## MANUFACTURERS' RECEIVER TROUBLE CURES

**VOLUME 6**

(CAT. NO. 143-6)

### **Improving alignment procedure (see Fig. 1).**

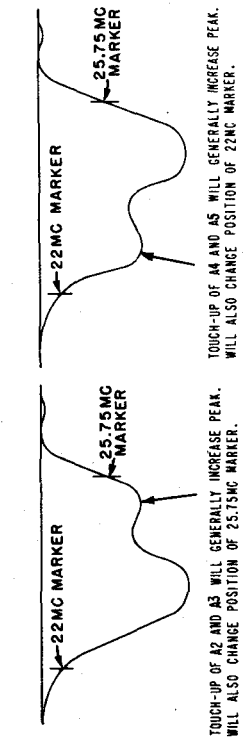
1. Instead of the original i-f response curves shown in the service notes, use the curves shown in part (A) of the figure. If it is necessary to adjust for approximate equal peaks and marker location, carefully adjust alignment slugs as instructed under the above figures. It should not be necessary to turn the slugs more than one turn in either direction. Note: Slug *A2* is the output transformer of 3rd i-f amplifier, slug *A3* is the input transformer of 2nd i-f amplifier, slug *A4* is the output transformer of 2nd i-f amplifier, and slug *A5* is the input tuned circuit of 1st i-f amplifier.

2. The overall response curves shown in the service notes should be changed. To correct the three curves, the dip in the curves shown near the baseline should appear on the left side of the adjacent sound channel trap (L301). The curves when corrected should appear as shown in part (B) of the figure.

When connecting a vtm or an oscilloscope to test point *V* (video detector load) as given under the alignment procedure, a decoupling filter consisting of a 10,000-ohm,  $\frac{1}{2}$ -watt resistor and a 330- $\mu\mu\text{f}$  capacitor should always be used. This filter is connected in the manner shown in part (C) of the figure.

Fig. 2 — Admiral

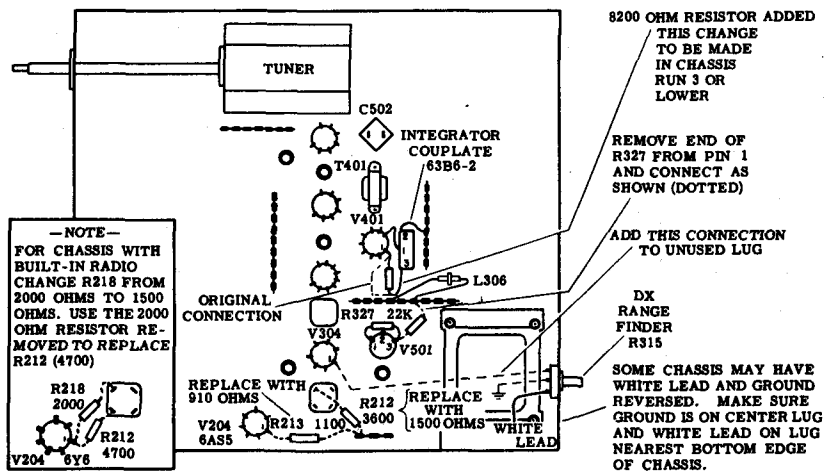
The horizontal stability of the 19-series chassis is improved with the use of a new vertical sync integrator Couplate, 63B6-11. The circuit of this Couplate is the same as the 63B6-2 Couplate used in chassis stamped Run 6 or lower, except that resistor *R407* (22,000 ohms) is not contained in this new Couplate. In-

stead, resistor *R407* is connected externally from terminal 3 of the Couplate to pin 1 of *V401B*. This change in integrator Couplates improves the horizontal sync stability by increasing the amplitude and “squaring up” the horizontal sync pulses.

This change represents a further improvement over that obtained with a Run 4 production change, which consisted of adding a 8,200-ohm resistor between terminal 3 of the Couplate and pin 1 of *V401B*.

To replace the old Couplate, 63B6-2, with the new improved Couplate, 63B6-11, omit *R443*, the 8,200-ohm resistor added at Run 4. Chassis stamped Run 3 or lower will not have this resistor. Connect *R407*, a 22,000-ohm, 1/2-watt resistor, 60B8-223, between terminal 3 of the new Couplate and pin 1 of *V401B*.

Fig. 3 — Admiral

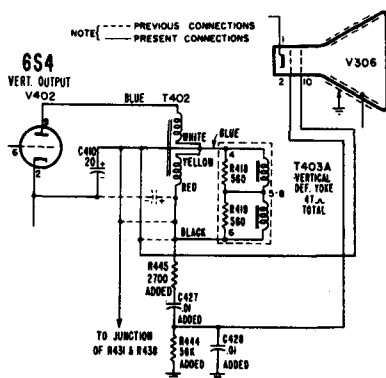
All 19-series chassis stamped Run 5 and higher have a vertical

retrace blanking circuit incorporated for eliminating retrace lines. A schematic of the retrace blanking circuit and detailed instructions for adding this change to an early production receiver, is given in the paragraphs below. The following parts are required:

3. Disconnect the red wire and the bare wire from their common junction point. Reconnect both of these leads to the junction of the 7.5-ohm winding and the 100-ohm winding of T402 (common point of the white and yellow leads). See figure.

Fig. 4 — Admiral

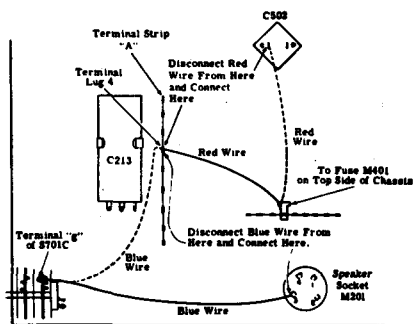
In some of the above chassis, the  $\frac{3}{8}$ -amp fuse *M401* may blow when the function switch is rotated from the Radio to the TV position. This occurs because in some 77B43

Function Switches, the rotor contact of the switch section *S701C* is wide and, during rotation of the switch, there is one position where all contacts on this section may short, resulting in a surge of current that blows the fuse.

If the  $\frac{3}{8}$ -amp fuse *M401* blows when rotating the function switch from the Radio to the TV position, this difficulty can be easily corrected without replacing or modifying the 77B43 switch *S701* by making a simple circuit revision consisting of changing the circuit location of the fuse, as illustrated. All 19-series chassis with built-in radios stamped Run 8 or above already have this change.

Fig. 5 — Admiral

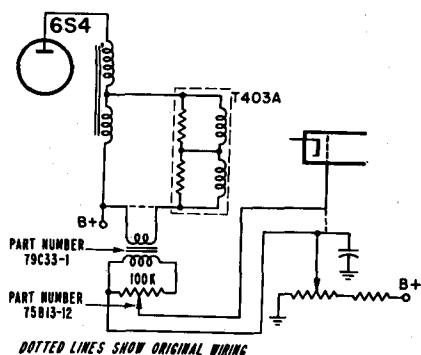
In some fringe areas, an increase in sound level can be obtained by detuning the 19.75-mc adjacent video channel trap *L108* (located between the plate circuit of the mixer and the grid circuit of the 1st i-f amplifier). When adjusting the fine tuning control on the re-

ceiver for best picture in fringe areas, the video i-f carrier moves to a higher position on the i-f curve and the sound carrier to a lower position. This places the sound carrier very near the frequency of *L108* and causes attenuation of the sound level. Therefore, by detuning the trap (*L108*), the sound level can be increased. Turn *L108* slug in about 1 or 8 turns or until no further increase in sound is apparent.

Fig. 7 - Admiral

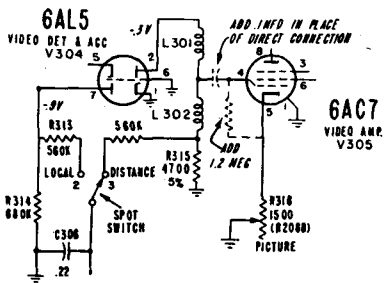
Lead dress is very important in the video detector and agc circuits in order to prevent high peak voltages from the agc circuit causing damage to the germanium diode. Be sure to:

1. Dress the germanium diode away from the white lead connected to pin 5 of agc tube (V304 6AU6).
2. Dress the white lead close to the chassis.
3. Dress the orange lead connected to pin 1 of agc tube (V304 6AU6) away from video amplifier tube (V305, 6AC7).

Fig. 9 — Admiral

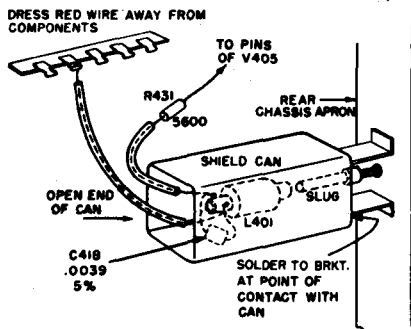
Horizontal ripple moving up or down in the picture is usually due to a power source frequency difference between the transmitter and the television receiver. It is caused by some of the 60-cycle power source voltage feeding into the horizontal oscillator. This a-c voltage can come from the B+ supply,

through the horizontal sync discriminator, and thus be applied to the control grid of the oscillator, or from flux leakage around the power transformer.

1. Disconnect the red lead from the lug on the horizontal lock coil (*L401*) and reroute it away from all chassis components. Reconnect the red lead to the lock coil lug. See the figure.

2. Replace the 5,600-ohm resistor which is connected between the lug of the lock coil and pin 2 of *V405* (6SN7) with a new 5,600-ohm, 1/2-watt resistor having longer leads or splice a wire to one lead of the existing 5,600-ohm resistor in order to lengthen it. Cover the resistor leads with spaghetti.

3. Remove the horizontal lock coil from the rear chassis apron by placing the fingers on the end of the coil form nearest the rear of the chassis and pulling the coil toward the front of the chassis. This leaves the slug and part of the assembly still attached to the chassis.

5. Slip the shield can over the slug, as shown in the drawing. The hole through the top of the can should be 7/16-inch diameter or larger.

Fig. 10 — Admiral

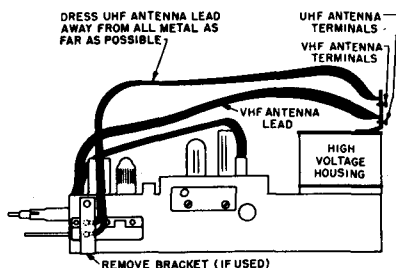
Poor performance of all-channel receivers on uhf may be caused

by the uhf antenna lead from the uhf antenna terminals to the uhf tuner being close to or touching the metal brackets of the rear picture tube mount. This lead is purposely long and acts as a quarter-wave trap at the mean frequency of the higher vhf channels.

Remove the back cover of the cabinet and check this lead to be sure it is not close to any metal and straighten it out if it is looped or doubled up. While the back is off the cabinet and after the antenna lead has been checked, check the lead from the uhf antenna terminals at the point where it is soldered to the side of the uhf tuner; see illustration. Remove the metal bracket (if used) that covers the uhf antenna connections. This bracket was used on the production line and is not required after the set is installed in the cabinet.

Fig. 12 — Arvin

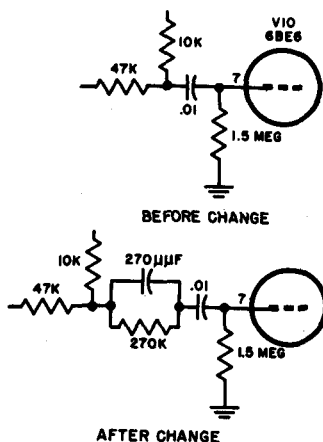
A definite improvement in overall sync stability under the presence of impulse-type noise interference in

fringe areas can be accomplished by lowering the screen voltage on the video amplifier, *V10* from 110 volts to 60 volts. Although this change may introduce a slight decrease in picture contrast, this should not prove to be detrimental on a comparison basis. The following additional parts are needed: a 4- $\mu$ f, 300-volt electrolytic capacitor and a 91 k-ohm,  $\frac{1}{2}$ -watt resistor.

2. Remove this wire from lug and reroute wire to blank lug of adjacent terminal strip, 1 inch away.

3. Add a 91k-ohm resistor between the old lug (110-v supply lug) and the new lug.

4. Add a 4- $\mu$ f capacitor between the new lug and the chassis ground lug connected to pin 7 of *VII*.

Fig. 15 - Arvin

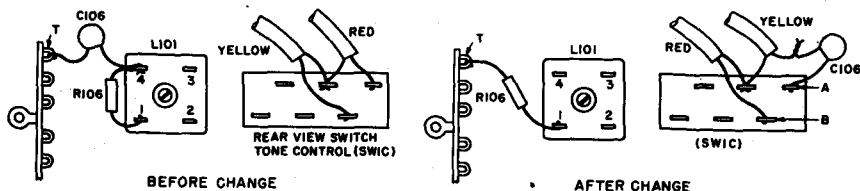
The purpose of this change was to improve the stability of the sound detector circuit by broadening the tuning of quadrature coil *L101*. The specific defect being corrected was the tendency of *L101* to drift off re-

sonance after warm-up, causing distorted sound.

1. Remove C106 from lug 4 on L101 and T on terminal strip.

3. Remove center conductor of yellow shielded wire from B on SWIC.

5. Add C106 from yellow wire in step (3) (connection made in space) to A on SWIC.

Fig. 19 — Capehart

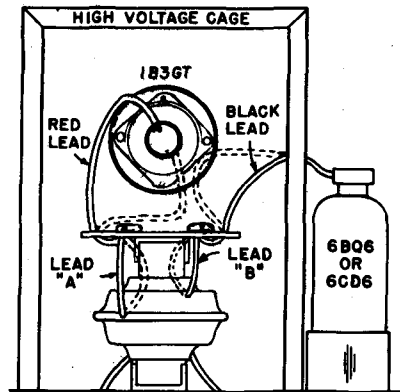
It is important that the dress of the leads in the h-v cage be checked carefully after replacement of any tubes or components in this section. In the drawing, proper dress of high potential leads within the h-v cage is illustrated by the leads which are drawn with solid lines. This is the position in which they are placed in manufacturing. Leads represented by dotted lines indicated examples of improper dress. Note that lead A and lead B must be separated from each other and looped away from the transformer winding (toward rear of chassis). The red and black leads must be dressed away from each other. The red lead can be properly dressed by rotating the 1B3 tube cap in a clockwise direction. The black lead can be properly dressed by rotating the 6BQ6 tube cap in a counterclockwise direction on a 70-

degree chassis or on a 90-degree chassis, and by rotating the 6CD6 tube cap in a clockwise direction.

Fig. 20 — Capehart

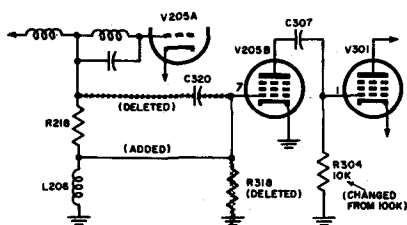
This change is incorporated in later production to eliminate the

sometimes apparent objectionable frying or hissing in the sound under extremely weak signal conditions. To make this change on early production chassis:

Fig. 25 — Conrac

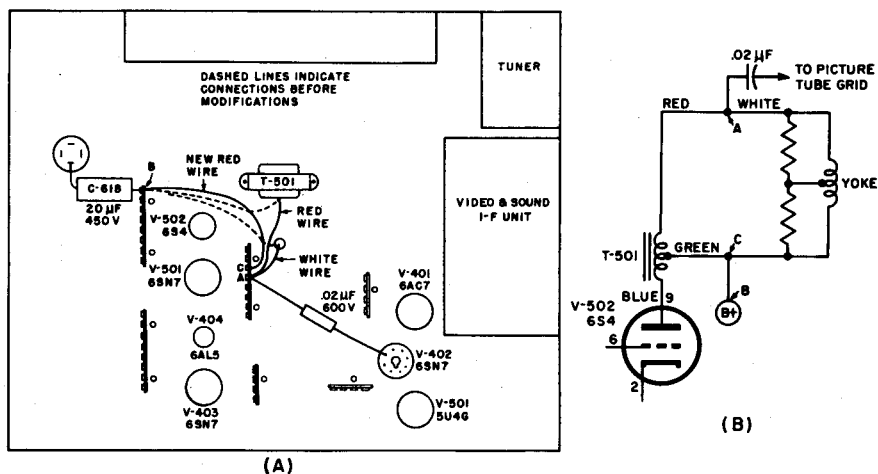
2. Remove red wire leading from *T501* (vertical output transformer)

from tie point *B* (*B+* boost) and reconnect to tie point *A*.

Fig. 27 - Crosley

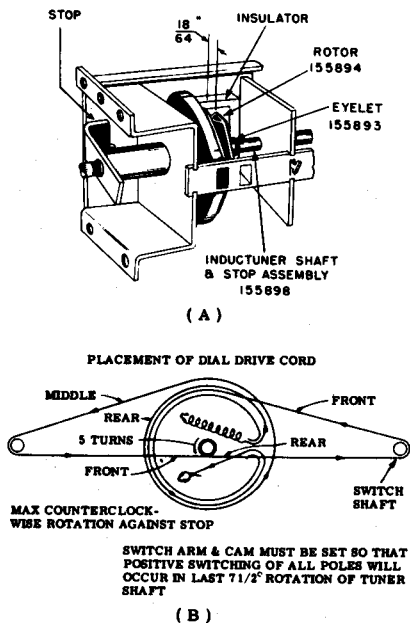
### Repairing damaged tuning mechanism (see Fig. 27).

The shafts and the fiber hub used in these converters have sufficient strength and flexibility to withstand normal handling and use. However, if a receiver is moved by grasping the control knobs, or if shafts are severely bumped or jar-

red, it is possible for the tuning mechanism to become damaged. Generally, the resulting damage will be a broken fiber hub on the control knob shaft or a loose stop on the knurled portion of the Inductuner shaft.

of pulley, and on the stop, so that the position of the scratch marks coincide. These marks will be used as a reference for correct positioning of the parts when they are re-assembled.

Fig. 28 — Crosley

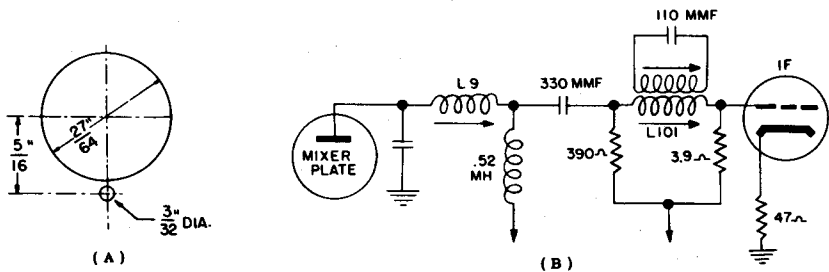
Note: Before soldering the stop to the shaft, make sure that the stop is positioned correctly on the knurled portion of the shaft with relation to the position of the rotors. To do this, turn the Shaft to its extreme counterclockwise position. The correct rotor position is shown in the figure, the 18/64-inch measurement is taken from the inner surface of the insulator to the corner of the metal plate that holds the contacts on the rotor. If the rotors are not positioned as shown in the sketch, remove the stop from the knurled portion of the shaft and then replace the stop on the shaft in a position that will result in the

rotors being in the position shown. The middle and rear rotor should be positioned on the shaft to coincide with the front rotor.

Fig. 36 — Crosley

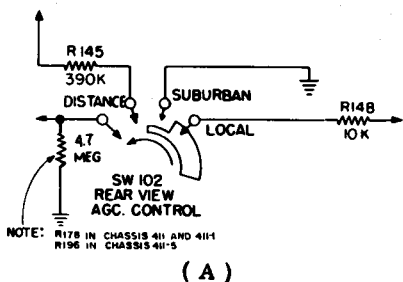
On later production of the above chassis (code letter *D* or later) a wiring change was made in the vertical circuit to avoid excessive height by reducing the plate voltage on *V110A* (vertical oscillator tube). However, no parts were added or deleted. The change on the schematic is shown in the figure. The figure shows also the correct color coding of the two leads of *L107A*, vertical

switch. The circuit for the Deluxe chassis is given in (A) along with the correct code letters; the circuit for the Custom chassis is shown in part (B) of the figure. This change is already made in later production.

Fig. 37 — Crosley

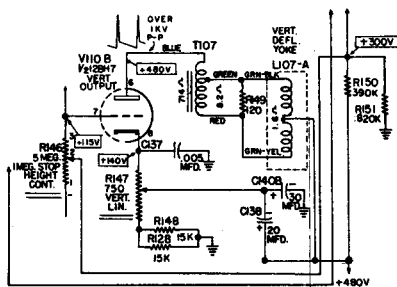
An improvement in the screen grid circuit of the horizontal output tube of the 24-inch chassis is made by adding a 1,800-ohm, 10%, 2-watt resistor (part No. 39374-204) in series with the other screen dropping resistor or resistors. It is added to guard against excessive high voltage in the above chassis. The change is already made in later production.

deflection coils. The colors for these two leads as shown in the schematic in the receiver service notes are incorrect.

Fig. 38 — Crosley

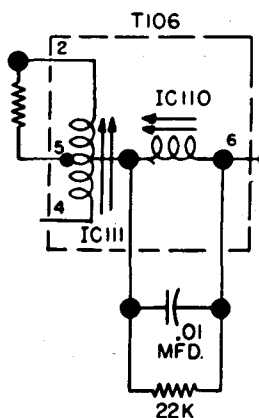
*Mounting the magnets.* The upper magnet may be mounted using the center hole in the flange at the top front of the deflection yoke bracket. The lower magnet may be mounted by soldering the end of the support strap directly to the deflection yoke bracket. It should be positioned so that the hole in the end of the strap is located on the vertical center line of the bracket and approximately 1¾ inches below the bottom edge of the large hole provided for the tube neck. An alternate method is to drill

a small hole in the deflection yoke bracket at this point and secure the magnet to the bracket using a suitable nut and bolt.

Fig. 39 — Crosley

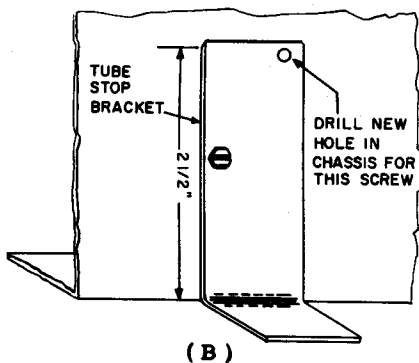
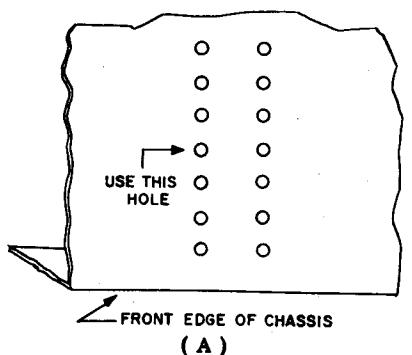
If horizontal drift is experienced due to humidity, replace the .01- $\mu$ f

capacitor that is connected in parallel with a 22,000-ohm resistor from lug 5 to lug 6 of the transformer *T106*. The replacement capacitor is treated with a special glazed coating and is stocked under part No. 148813-2. Replacement capacitors (part No. 148813-1 or 148813-2) that do not have the special glazed coating may be used in less critical circuits.

Fig. 40 — Crosley

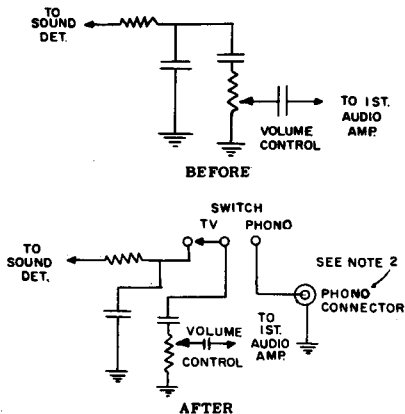
1. A switch will be necessary in order to switch the high side of the volume control from television sound detector output to record player input (TV-Phono switch, part No. 14 8260 is suitable.)

2. A phono connector of some sort should be used so that the record player can be disconnected easily by unplugging from the television chassis. (Phono connector part No. 136 998 is suitable.)
